Turbochargers NR24/R and NR26/R
Modification of the compressor wheel seat and labyrinth
ring for engines with impulse-pressure supercharging

Cus 177 • 03/00

Figure 1. Modified rotor

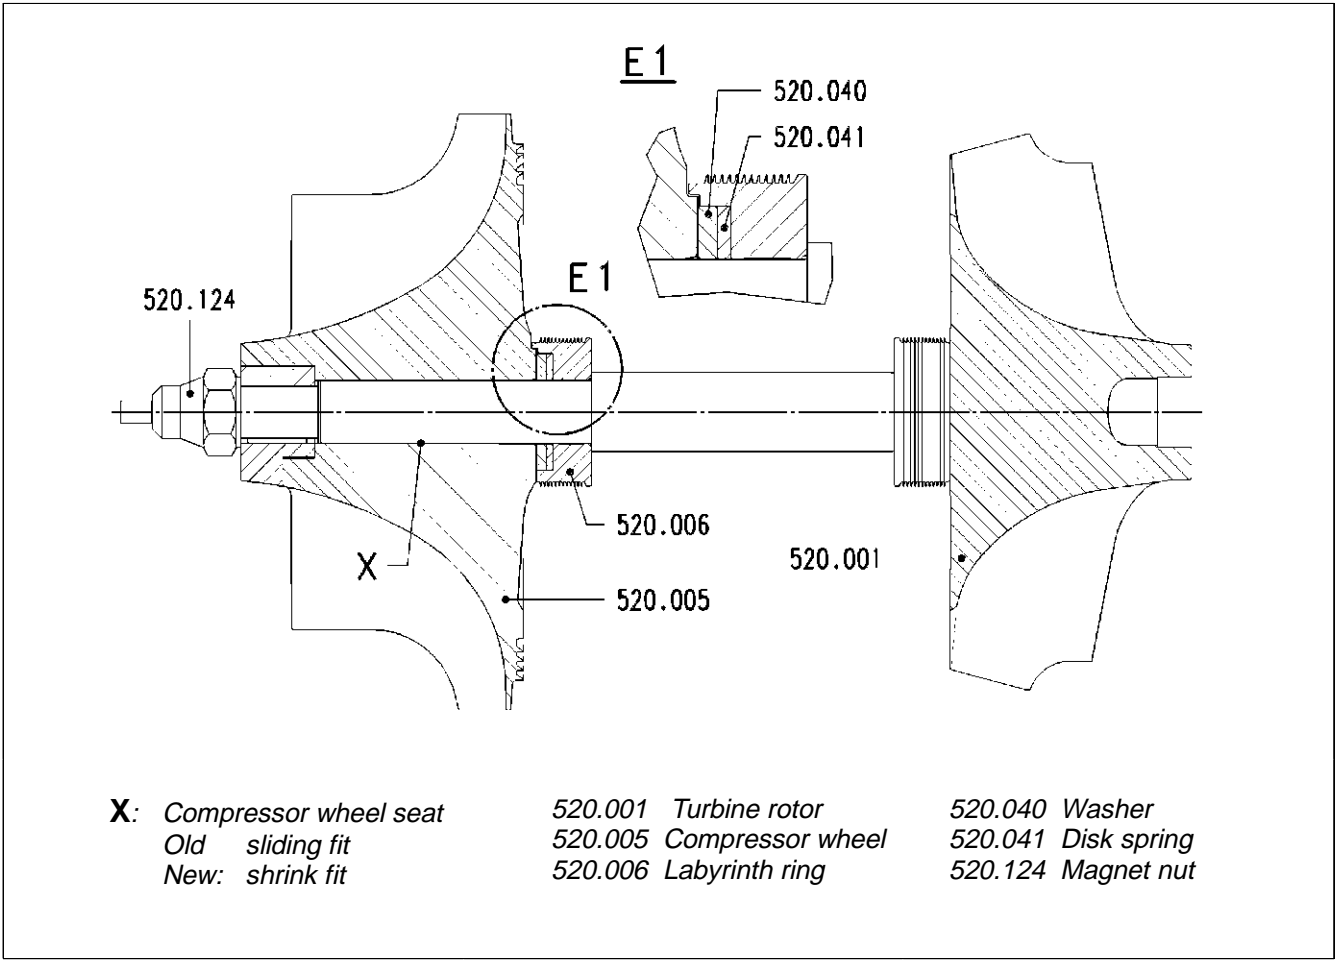
Reasons for the modification	The high stresses on the rotor from the pulsating exhaust gas in engines with impulse-pressure supercharging caused damage to turbochargers of sizes NR24/R and NR26/R; in some cases, this led to failure of the turbocharger after a relatively short operating period.
Type of damage	On the damaged parts, fretting corrosion was found on the compressor wheel, axially on the contact surface between the rear of the compressor wheel and the labyrinth ring. The fretting corrosion observed on the axial contact surfaces enlarges the axial lubricating gap, so that the equilibrium of lube-oil supply to the bearings is disturbed. The result is insufficient lubrication of the bearing on the turbine side and excessive wear of the bearing bush, causing failure of the turbocharger.
Improvements	<p>In order to improve reliability, the seat of the compressor wheel and the labyrinth ring have been modified, and the tightening torque has been increased in the</p> <p style="text-align: center;">NR24/R from 120 Nm to 240 Nm, and in the NR26/R from 190 Nm to 350 Nm,</p> <p>by using a titanium or steel nut.</p> <p>By installing a disk spring (see Figure 1) as well, a constant pre-loading is provided, which prevents fretting corrosion in case of pulsating admission.</p>

Notes on installation	<p>Due to the alteration of the compressor wheel's seating from close sliding fit to shrink fit, the compressor wheel must be warmed up before installation or removal. To do this, heat the compressor wheel carefully and uniformly with a suitably adjusted flame in the vicinity of the hub between the blades to a temperature of 80°C.</p> <p>Before installation, the heating can also be done by means of a hot-plate. As soon as the warm compressor wheel has been mounted, tighten the magnet nut with the specified tightening torque. Since the compressor wheel shrinks axially while cooling, the tightening torque must be checked again when it is cold.</p>
Retrofitting	Turbochargers supplied previously can be retrofitted correspondingly.
